Appendix A2

Independent Geotechnical Expert Review Panel Reports

**Report No 5
Meadowbank Mine Dike Review Board
Meeting December 17-18, 2009**

**RESPONSE TO REPORT NO.5 MEADOWBANK MINE DIKE REVIEW BOARD, DATED JANUARY 5, 2010
SUBJECT: REVIEW COMMENTS**

Photo # 8 Bay-Goose, material for fine filter from non PAG rock

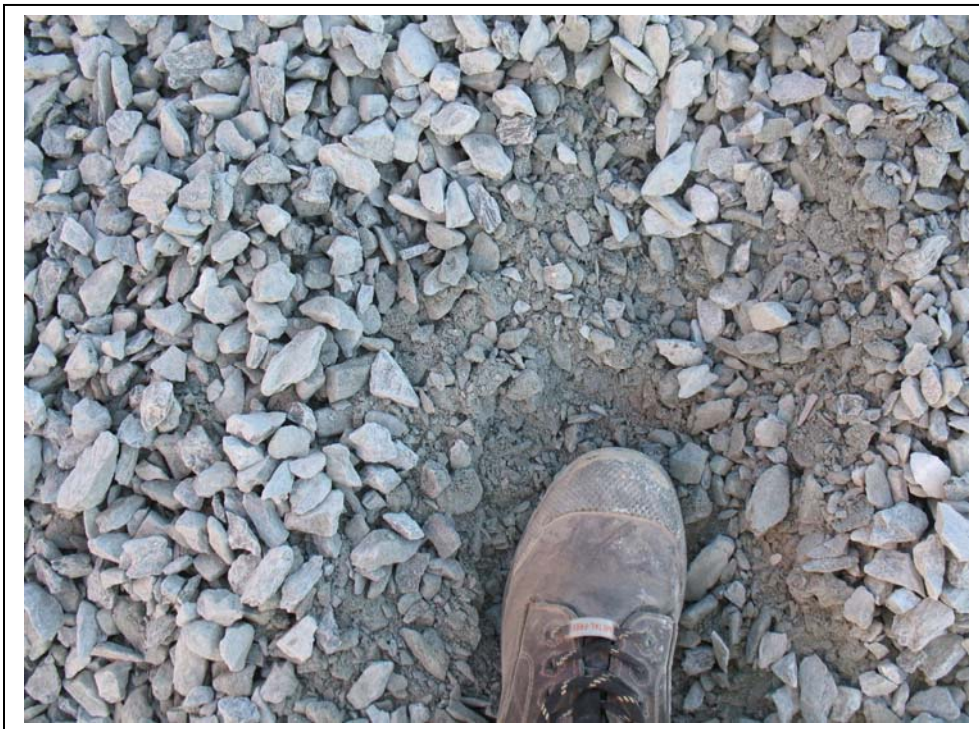
Comment: *The stockpile of fine filter material was examined and the Board remarked on the apparent high fines content (photo # 8). This non-PAG material is produced from relatively friable volcanic rock and the crushing and handling may generate excessive fines. However, the grain size analyses, transmitted subsequent to the Board meeting...indicate the material to be well graded and within the specified envelope except for a small fraction of oversize particles. As the materials were dry when observed it is possible that some segregation on the outer slopes of the piles may have contributed to the perception of a less well graded product. Nevertheless, it is evident that care is required in the exploitation of the stockpiles, particularly when dry, in order to minimize the segregation.*
